Fw: Fwd: Frei Quarry Opposition Letter

From: timpreister@aol.com
To: peter.hays@state.co.us, jared.ebert@state.co.us, russ.means@state.co.us
Sent: 9/10/2021 12:28:50 PM Mountain Standard Time
Subject: Frei Quarry Opposition Letter

We are strongly opposed to the proposed Frei Quarry expansion, an expansion that will nearly double the quarry footprint to approximately 750 acres.

(C.) Silt erosion from Gilpin Waste Fines Dump site into North Clear Creek

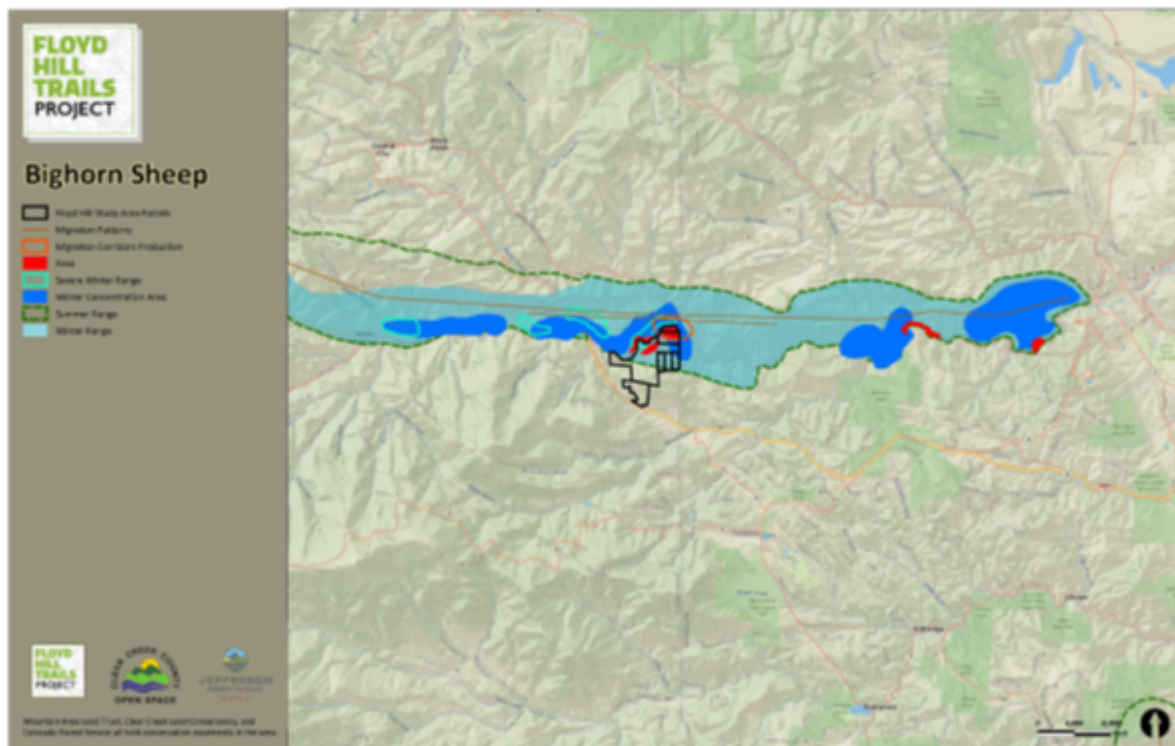
2. In our opinion, the Frei Quarry has already wrought **severe aquatic environmental damage and the expansion poses additional threat to Clear Creek**, a natural wild brown trout fishery that is valued by thousands of Front Range anglers, tourists, trout stream conservationists and Colorado Parks and Wildlife. The heavy wash from the Frei "fines" dumping slope reached the North Fork of Clear Creek about seven years ago via Gilpin County and to the best of our knowledge has never been repaired, addressed or tested for heavy metals. The murky tailings waste still drains downstream into the main stem of Clear Creek, in Jefferson County, within a few hundred feet. See photos (C.) below of silt erosion into North Clear Creek from April 1, 2014.
